# SERVICE BULLETIN

M-1208A

Safety Recall Code 0131

## 2006-2007 XL EXHAUST SHIELD RECALL

Figure 1. Inner Exhaust Shield Installation on Rear Exhaust Pipe

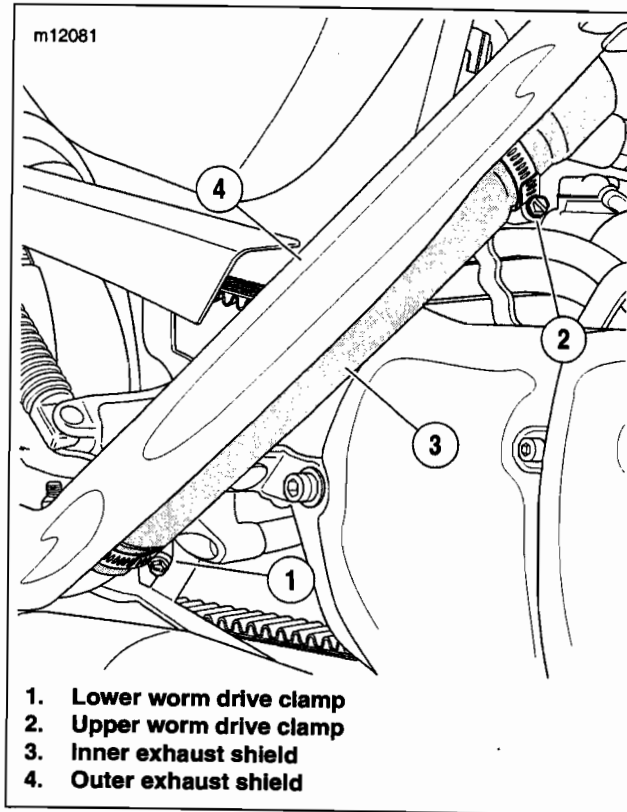
See Figure 1. If the vehicle is equipped with an original rear exhaust pipe (header) which does not have the inner exhaust shield installed, proceed to the installation instructions.

1. See Figure 1. Loosen the lower worm drive clamp (1) on the rear exhaust pipe.
2. Loosen the upper worm drive clamp (2).
  - a. See Figure 2. On 2006 model vehicles, loosen the upper worm drive clamp. Rotate the clamp (1) to accommodate the installation of the inner exhaust shield as shown.
  - b. On 2007 model vehicles, completely unfasten the upper worm drive clamp until the clamp opens.
3. See Figure 1. Slide the bottom portion of the **new** inner exhaust shield (3) against the exhaust pipe and into the lower clamp. The clamp should rest on the indented portion of the inner exhaust shield.

4. Tighten lower clamp securely.
5. Place the upper portion of the inner exhaust shield against the exhaust pipe.
6. Install the upper worm drive clamp(s).
  - c. See Figure 2. On 2006 model vehicles, install a **new** worm drive clamp (Part No. 9955) on the indented portion of the inner exhaust shield. Tighten both upper clamps securely.
  - d. See Figure 1. On 2007 model vehicles, install the upper clamp over the indented portion of the inner exhaust shield. Tighten clamp securely.
